ADDENDUM NO: 3

PROJECT: Hamilton Heights High School Phase 2 Projects

PROJECT NO: 2023060

DATE: 03/05/2024

OUTBUILDING
UNDERSLAB
PLAN -
PLUMBING

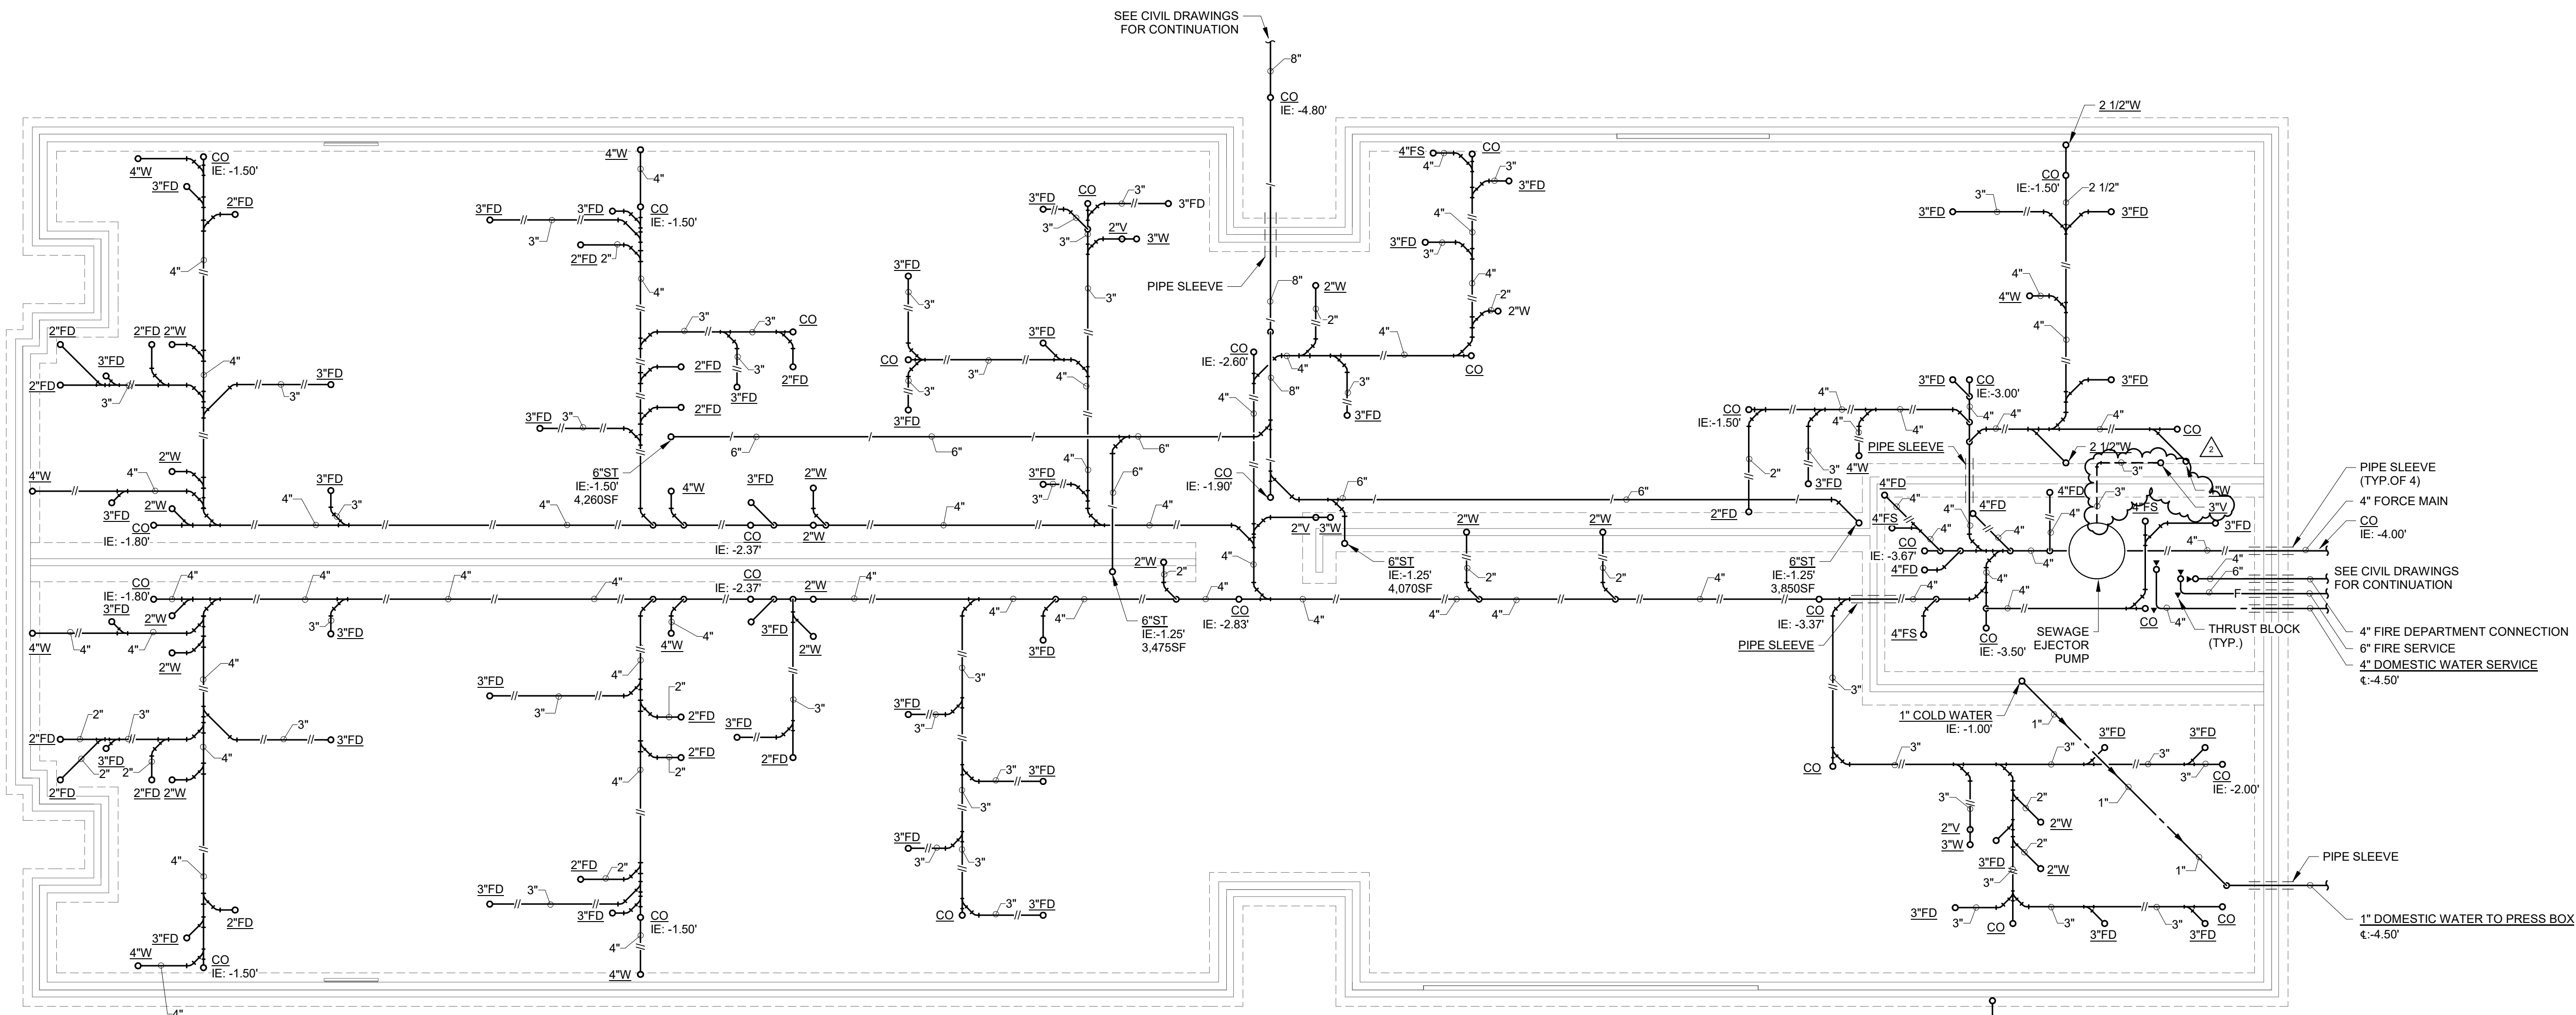
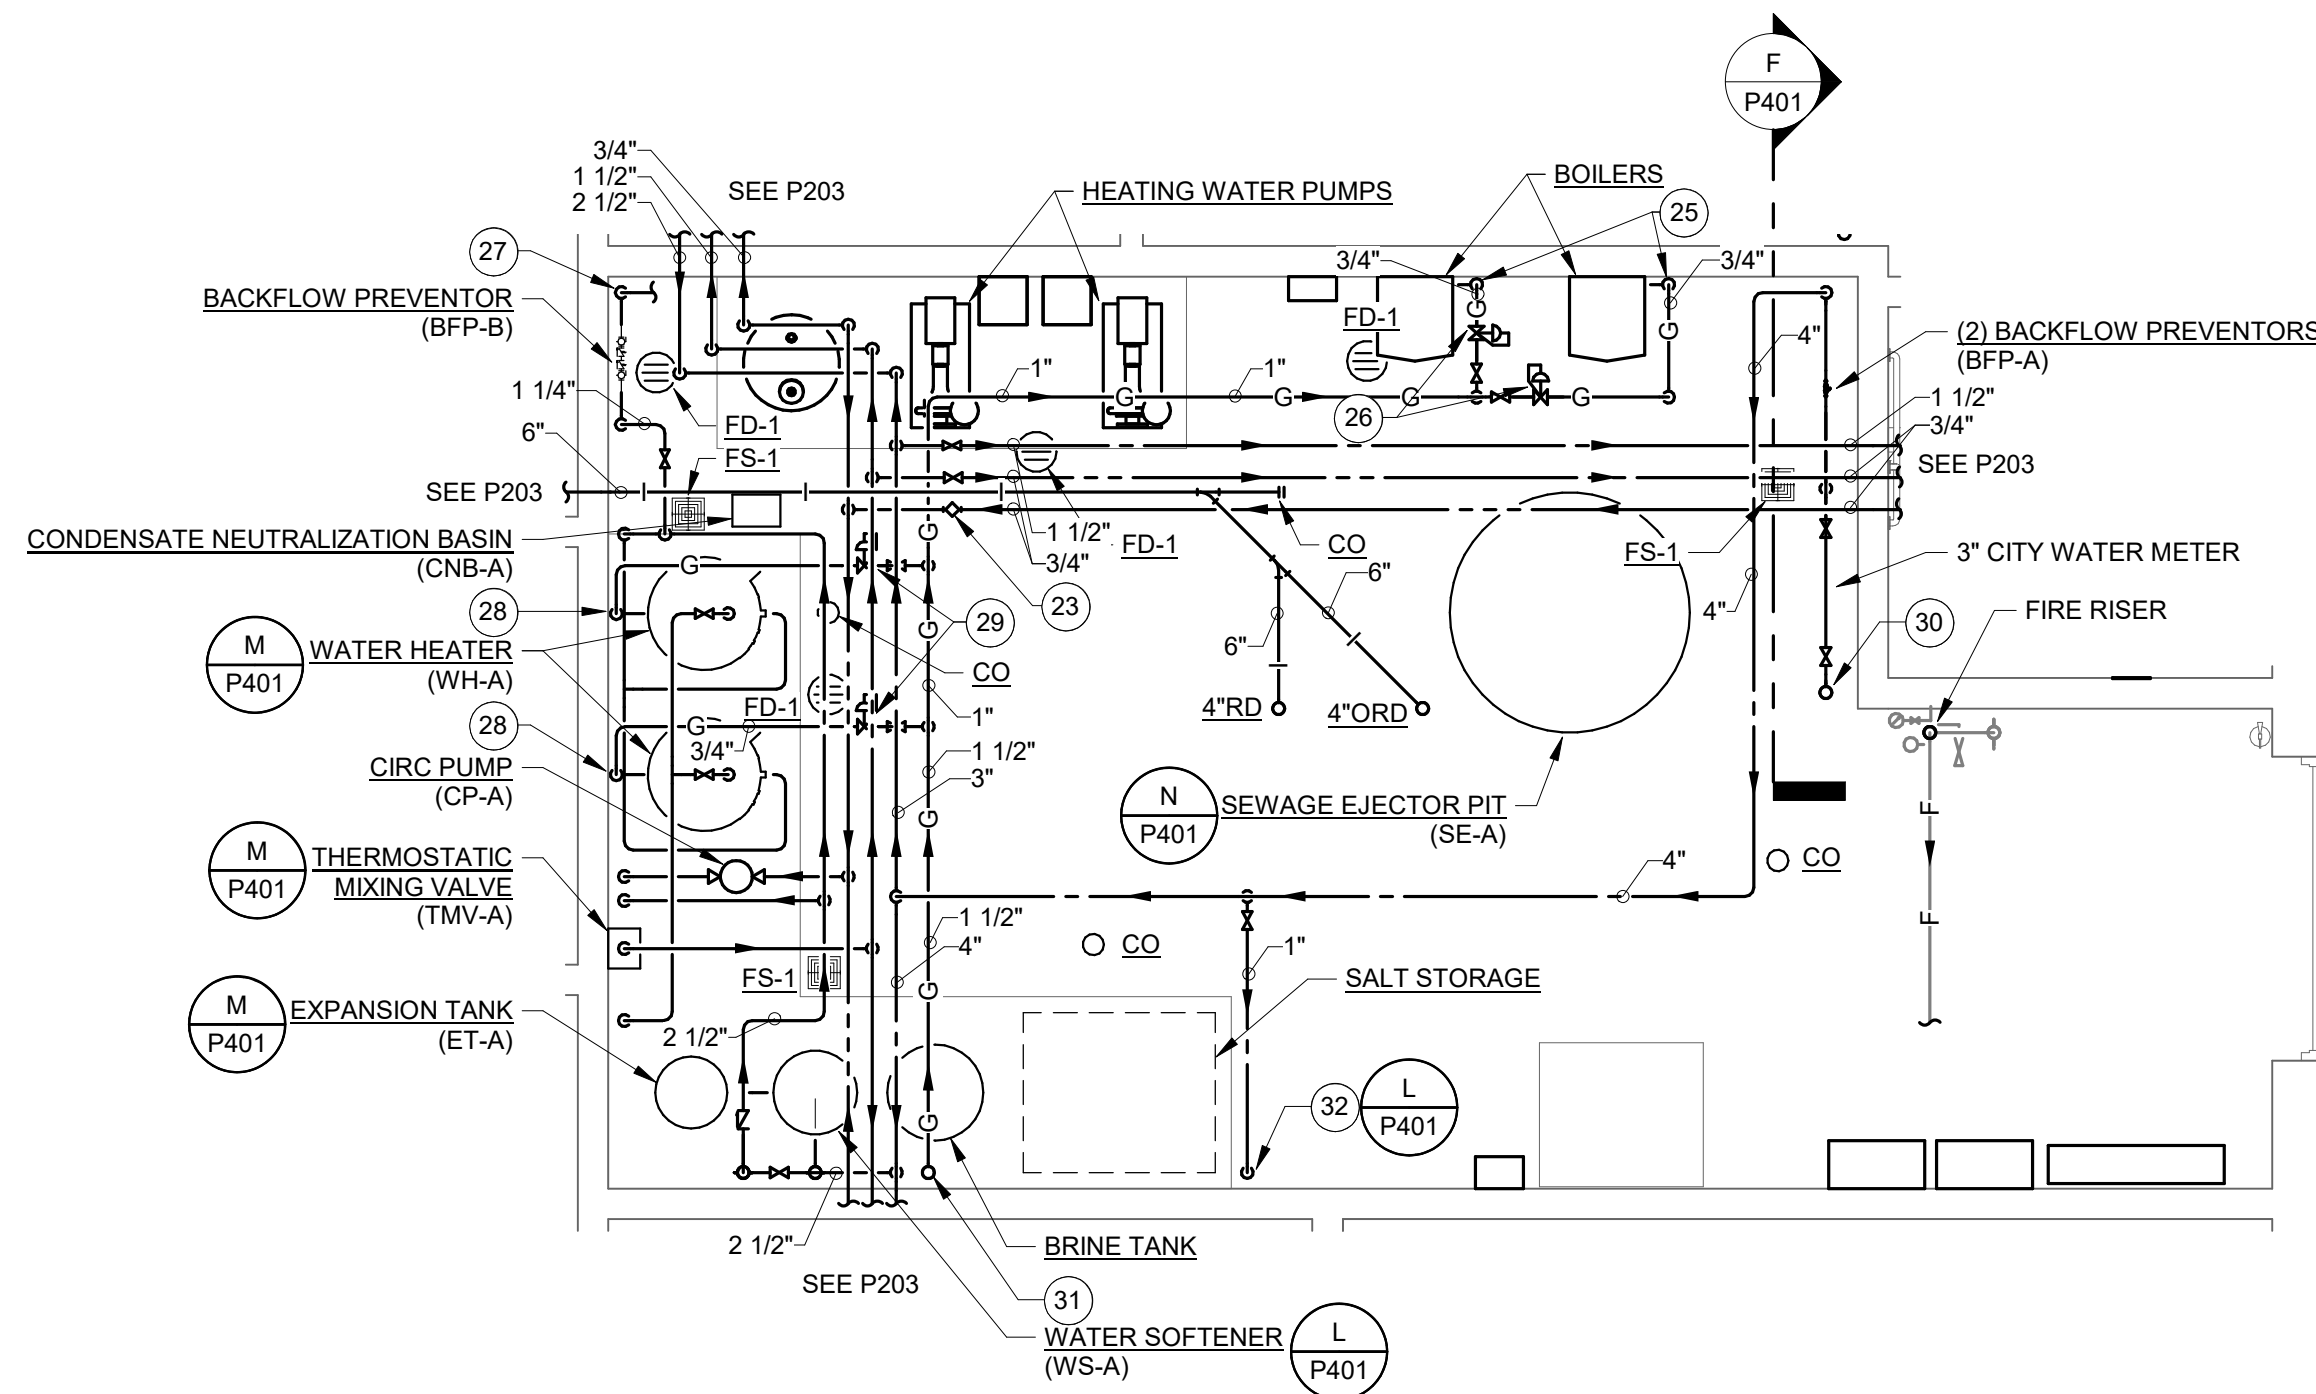
3.8 P103 – OUTBUILDING UNDERSLAB PLAN – PLUMBING

- A. Add 3" vent to sewage ejector pit

DRAWING NUMBER
P203

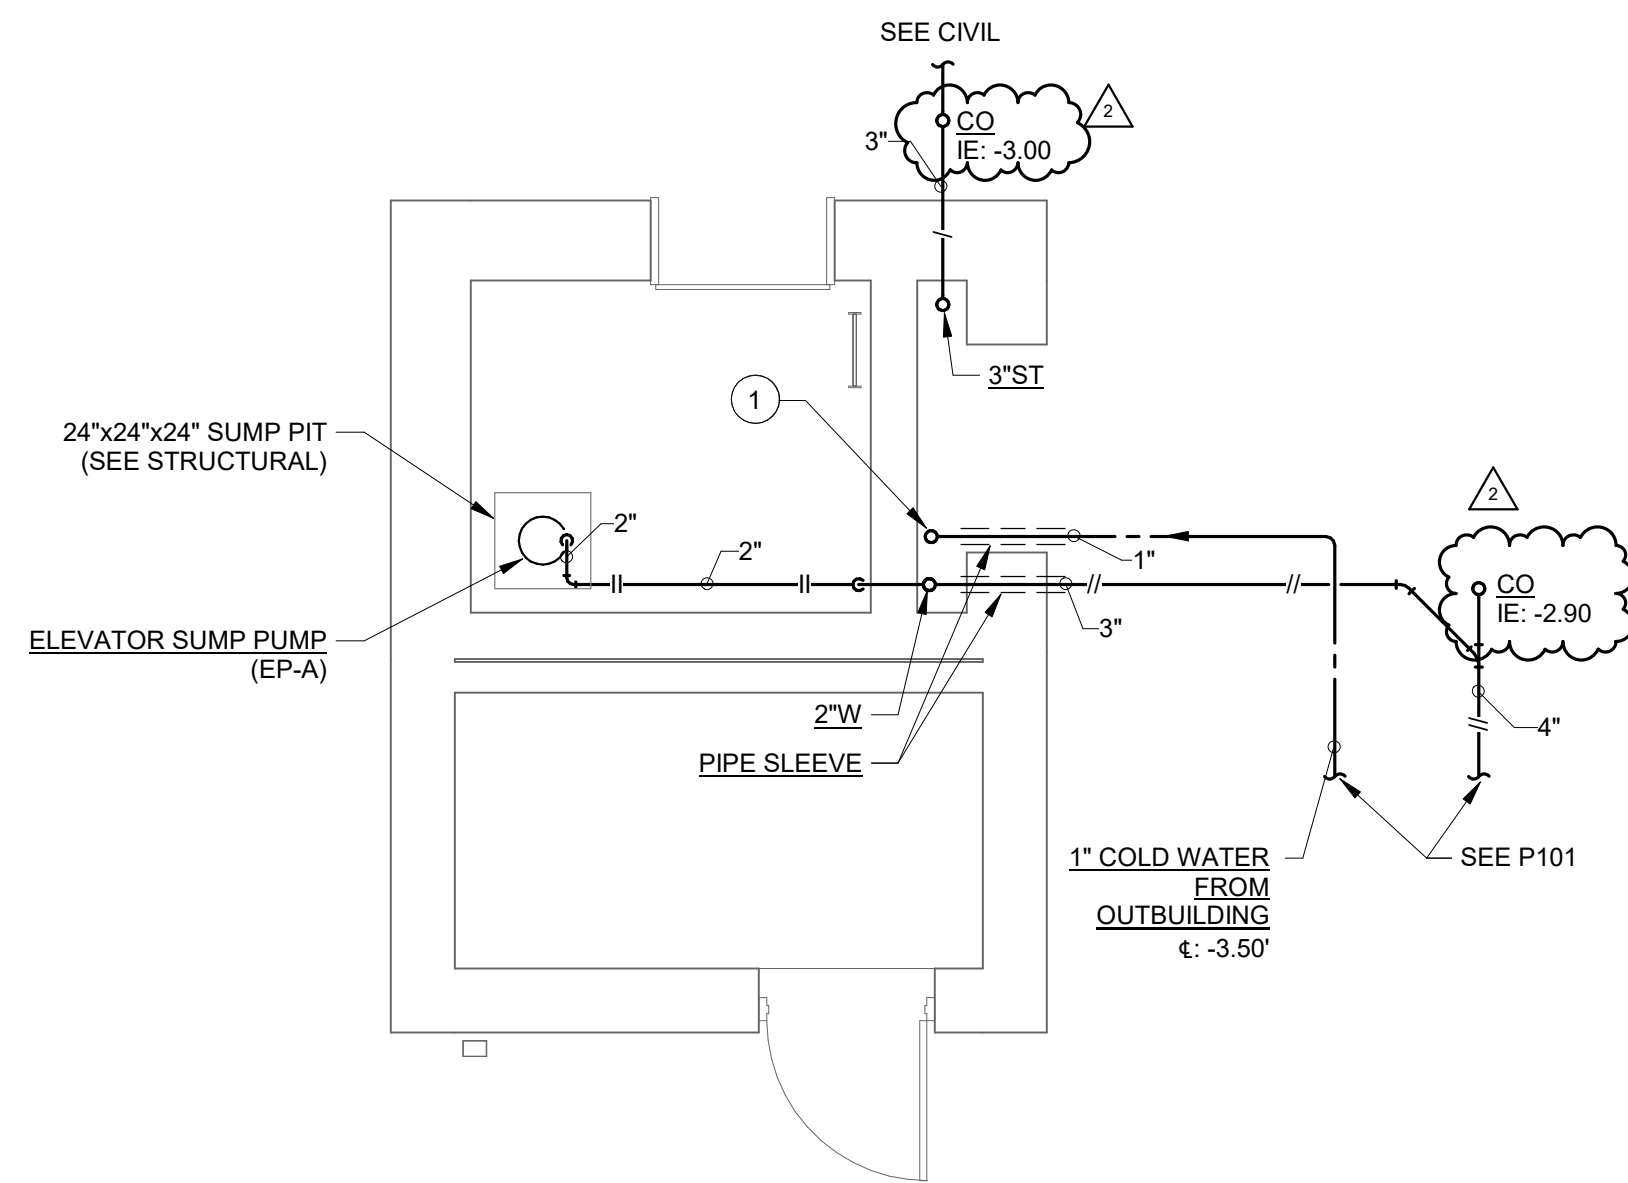
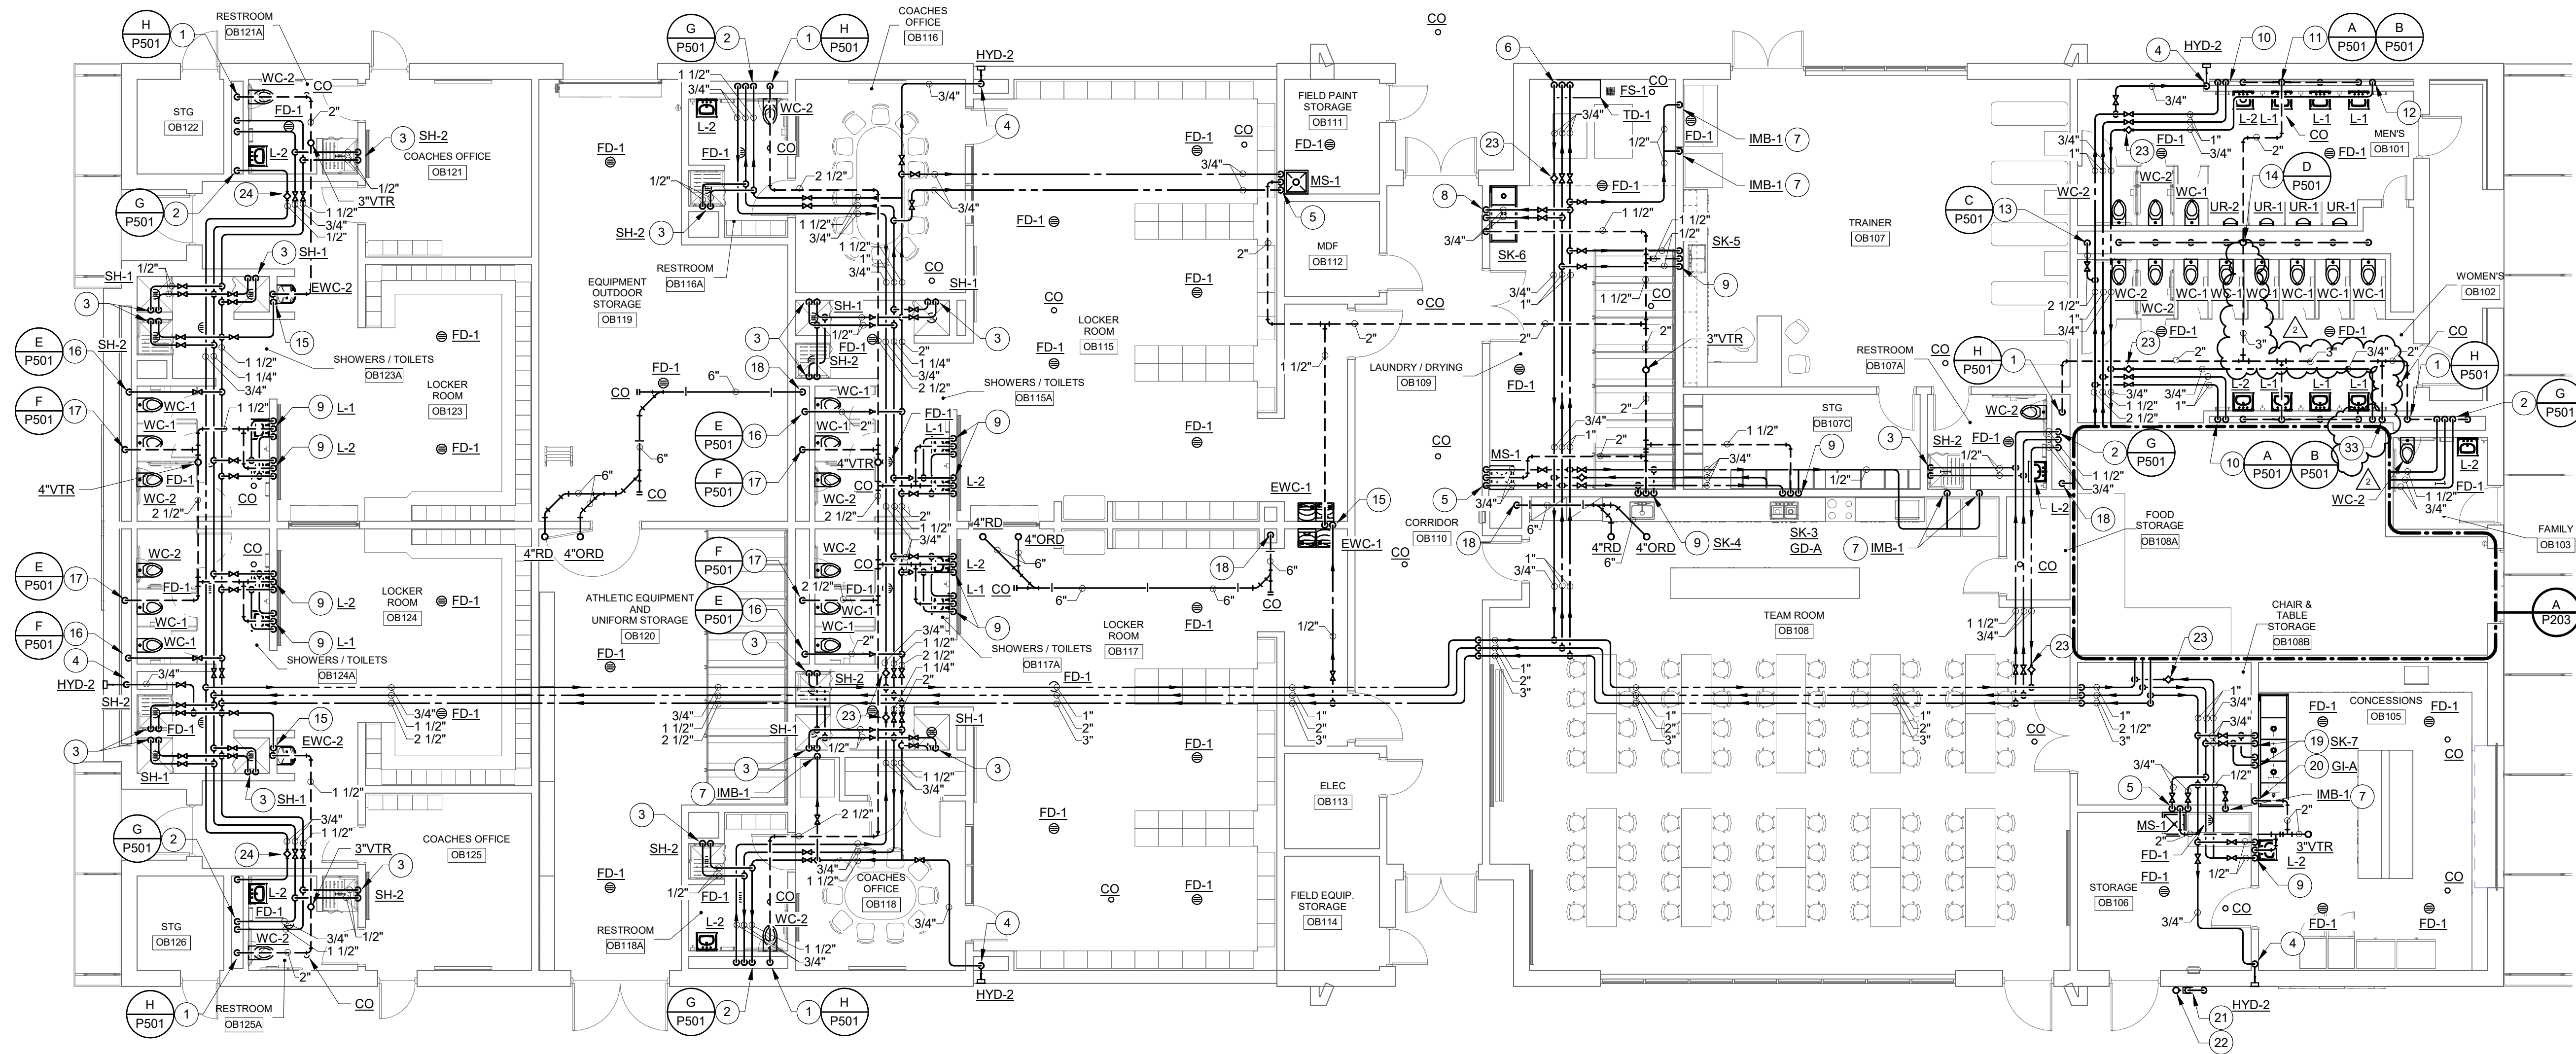
3.9 P203 – OUTBUILDING FLOOR PLANS – PLUMBING

- A. Add 3" vent for sewage ejector pit.
